Notification of change

Design change of M12 screw plug for the unoccupied M12 sockets– CBF200097

- Plastic version

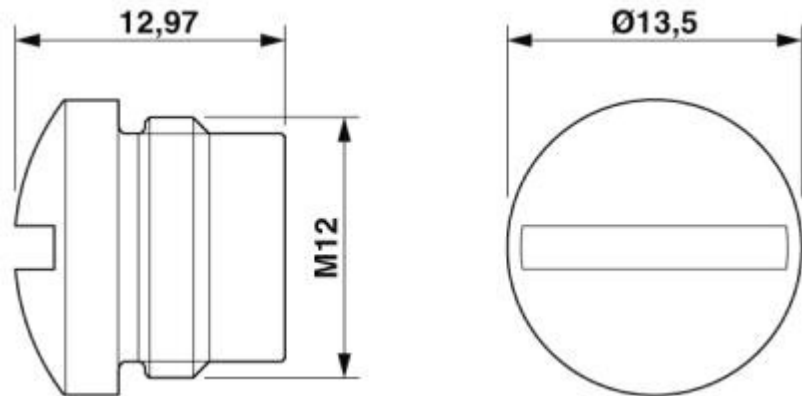
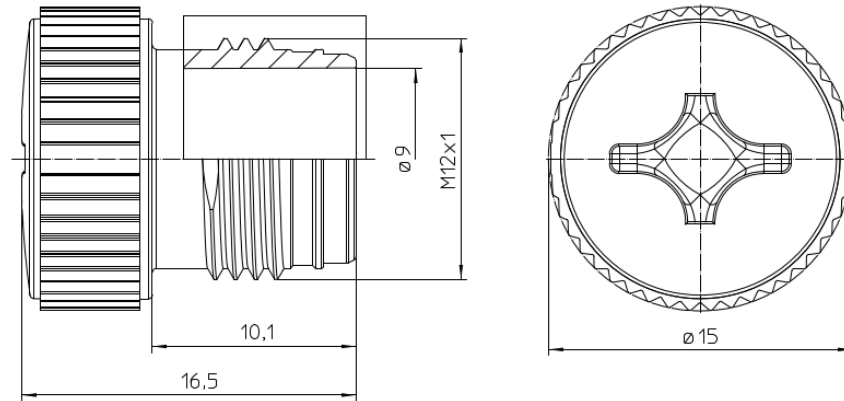
- **Plastic version**
- Inner diameter increased for M12 Power Codings
- M12 Push-Pull contour added
- From slotted to slotted / Phillips screwdriver

- Metal version

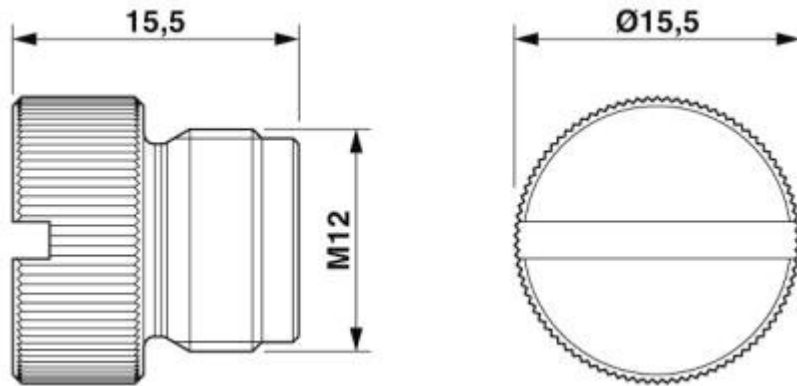
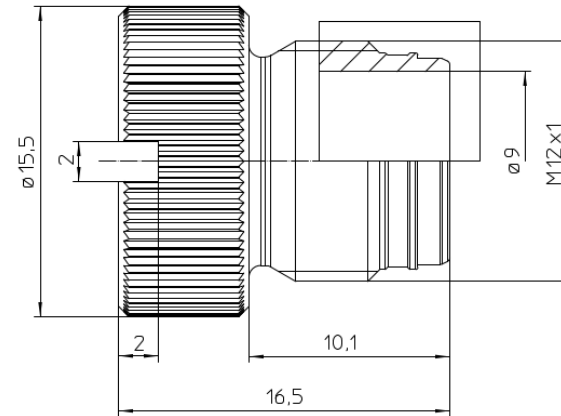
- **Metal version**
- Inner diameter increased for M12 Power Codings
- M12 Push-Pull contour added
